**PERSIMMON HOMES THAMES VALLEY
LAND NORTH OF TODDINGTON LANE,
LITTLEHAMPTON**

**DRAINAGE STRATEGY, WEST OF
WETLANDS
(DISCHARGE OF CONDITION 10)**

Project Code:	A/PHDRAIN.10
Prepared by:	SF
Approved by:	AB
Issue Date:	24th January 2019
Status:	1st Issue

From: Laura Gibbons <[REDACTED]>
Sent: 16 January 2019 11:05
To: Sean Foley
Cc: Clark, Robert; Michael Eastham; Edgley, Martin; Adrian Barnley; Steven Lecocq; Fatima Evernden; Tracey Headley-Smith; Alex Wray; Adam Winstone
Subject: RE: Planning Consultation on LU/345/18/DOC

Image below shows the locations of the permeable sub-base within the Windes model..

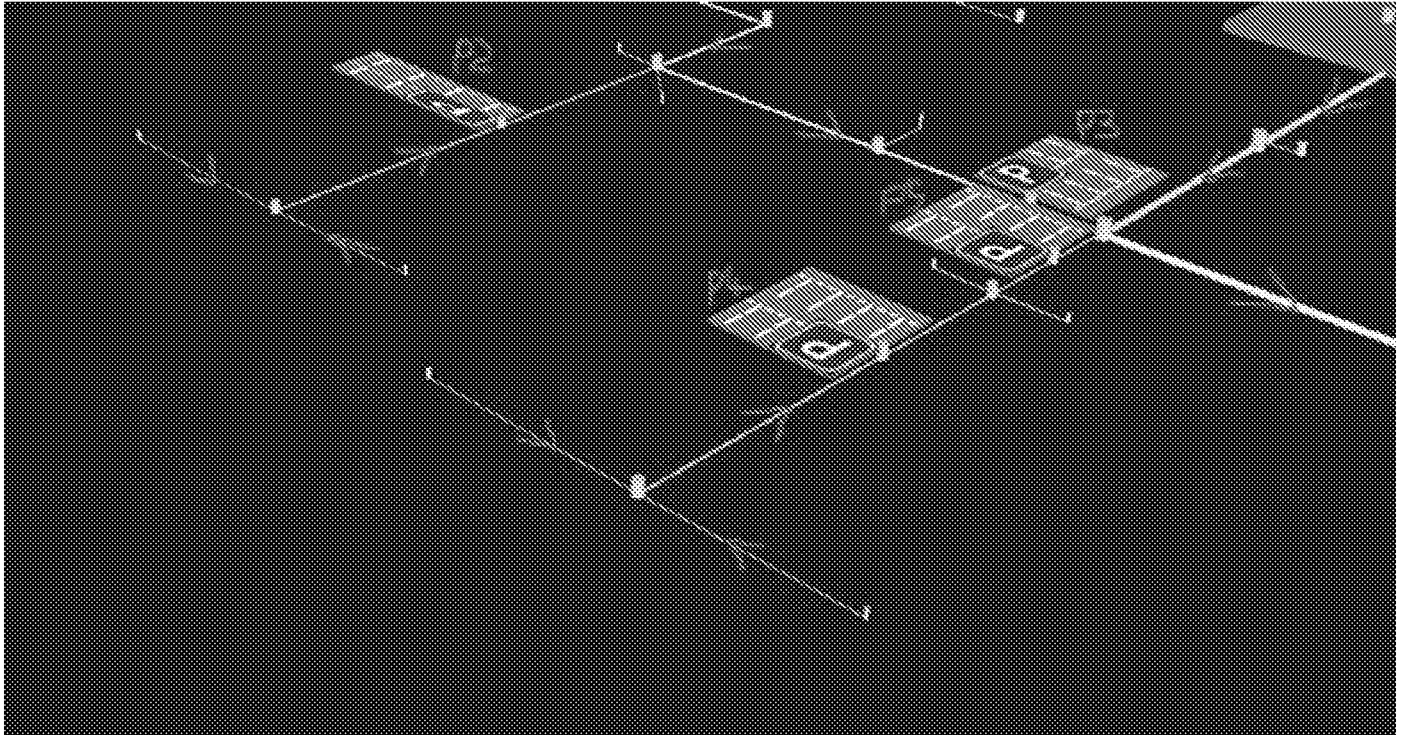
Whilst reading the response below please note we have updated our Windes model so it now includes the permeable sub-base. See image below where we've added new nodes and modelled it as a "porous car park" (function within the programme) where the storage within 30% voids of the granular sub-base is recognised. We have distributed it as evenly as possible across the areas where the granular sub-base is located. The addition improves the results significantly and the total flooding volume for the fully surcharged critical 1in100yr+CC storm is now only 35m³ (spread across 4 different locations) that can safely be contained within the site.
